Southeast Alaska Integrated Resource Plan

Black & Veatch's Errata Sheet

Volume 2 – Technical Report

Figure 2-3 Elements of Stakeholder Involvement Process

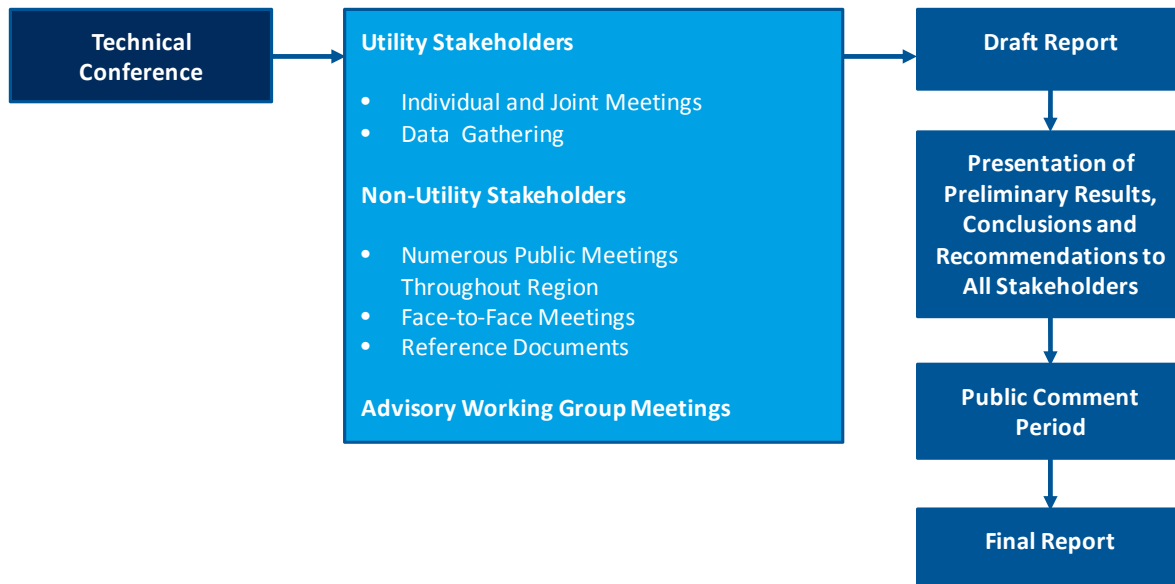
Page 2-6, Figure 2-3. Figure 2-3 has been revised and is attached.

Figure 4-5 Proposed Petersburg to Kake Interconnection (Northern and Center-South Routes)

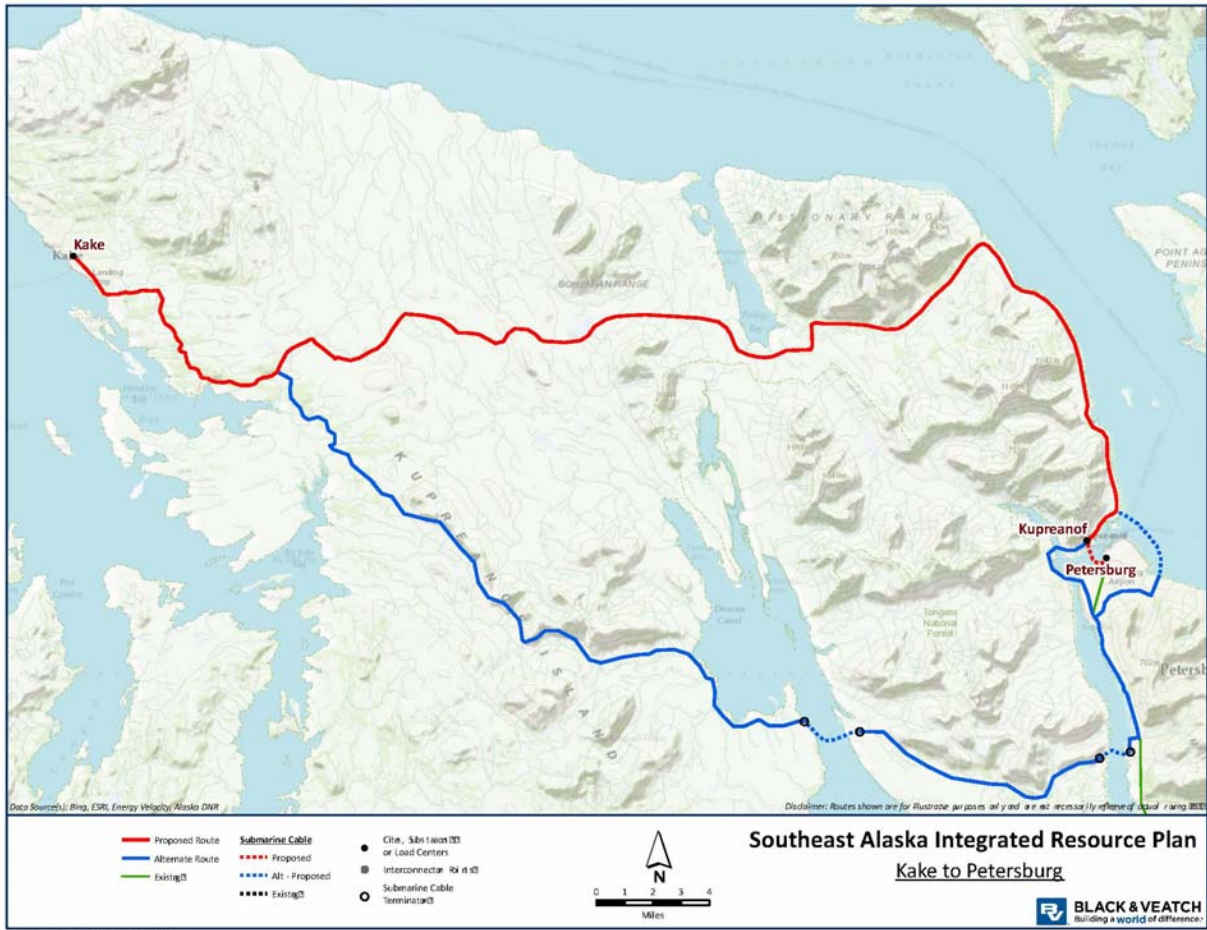
Page 4-35, Figure 4-5. Figure 4-5 has been revised and is attached.

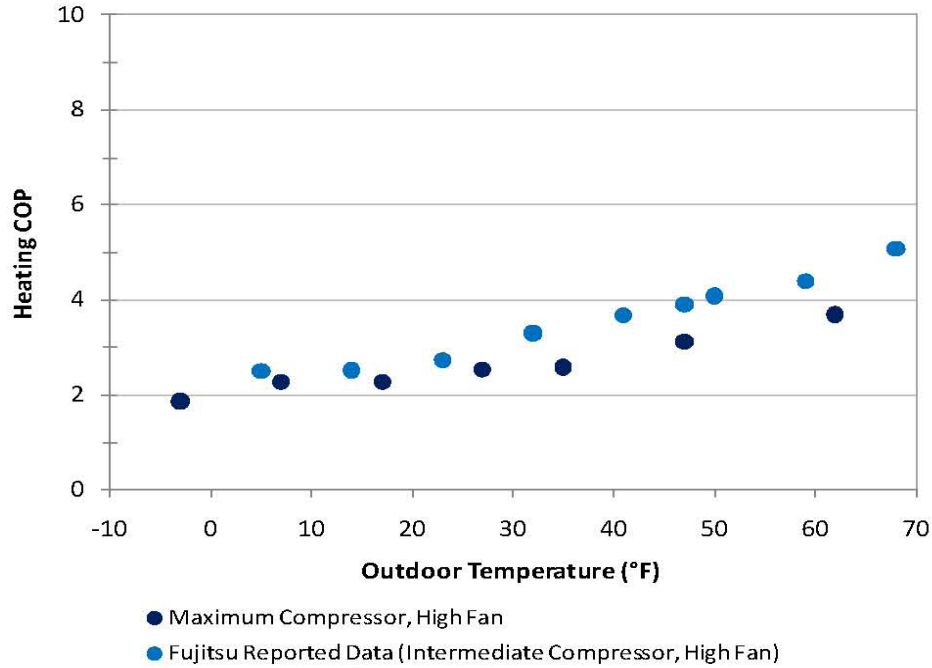
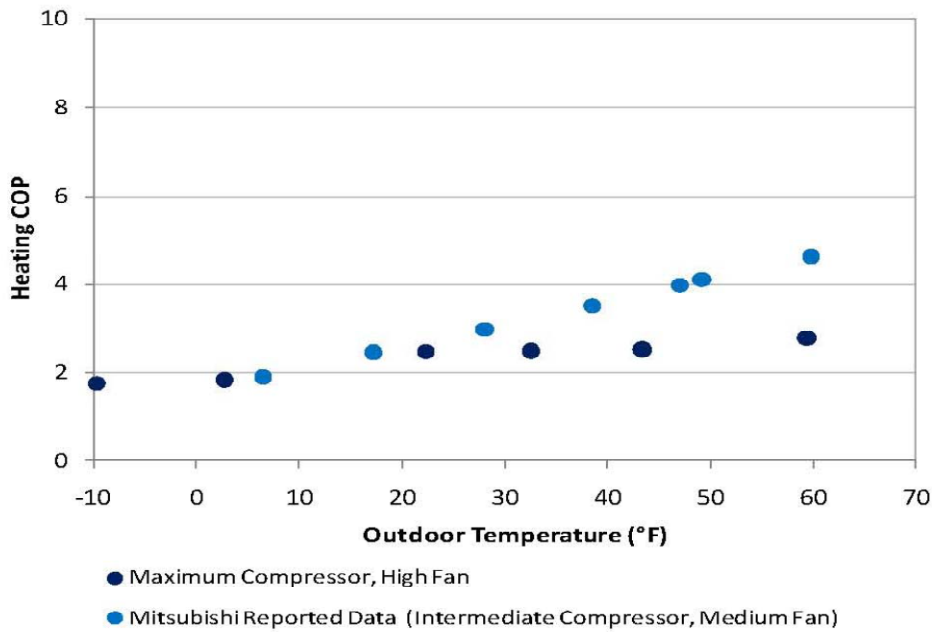
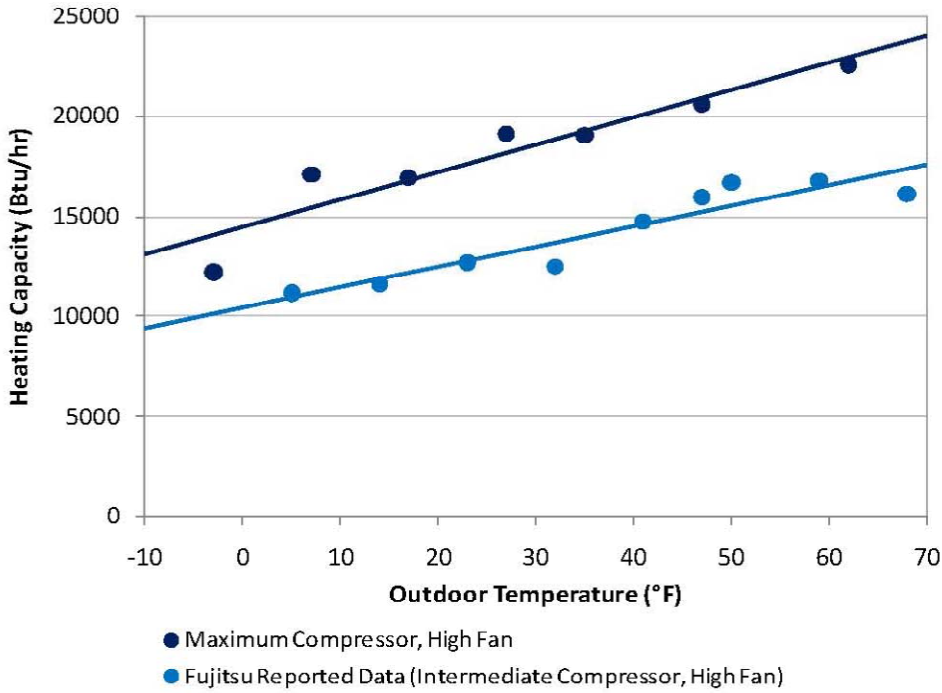
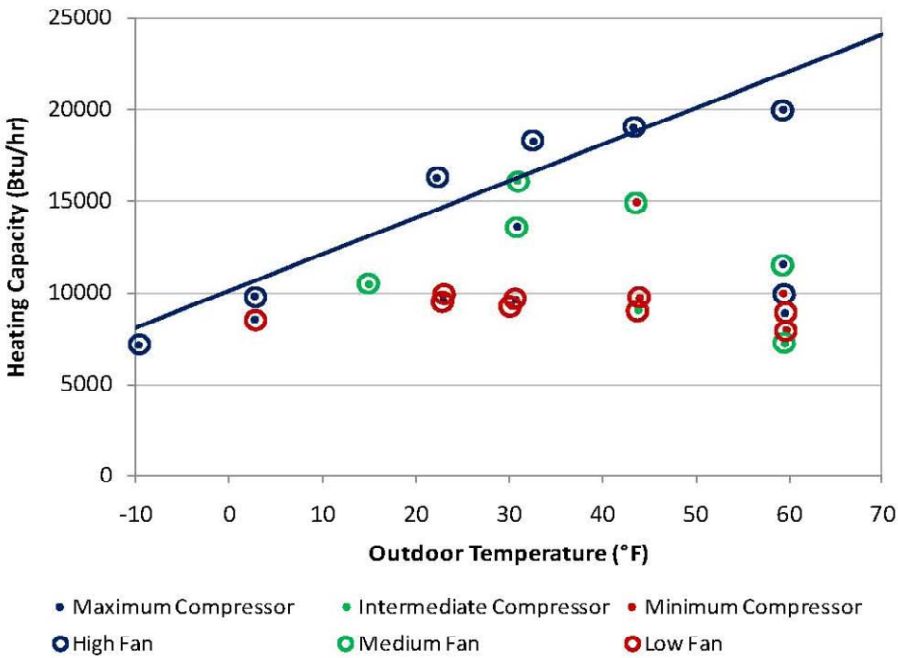
Pages 16-22 through 16-26, Section 16.3.3. Black & Veatch has revised Section 16.3.3 in response to comments regarding heat pumps to better place heat pumps in the proper context. In addition, Table 16-9 in Section 16.3.3 has been replaced to eliminate confusion over the breakeven energy cost between pellets and heat pumps. The revised Section 16.3.3 is attached.

Figure 18-1 Southeast Alaska IRP Annual Capital Requirements

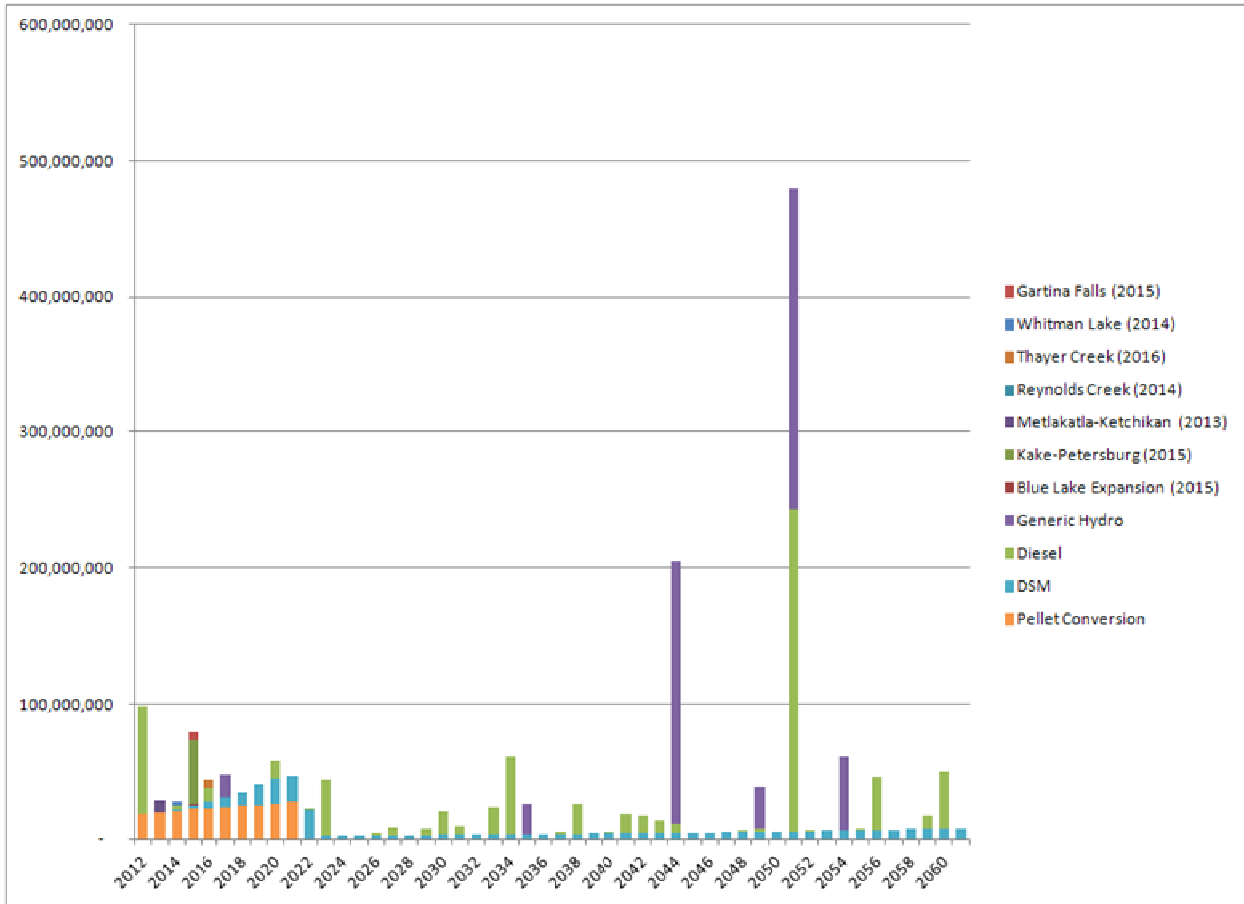
Page 18-1, Figure 18-1. Figure 18-1 has been revised and is attached.
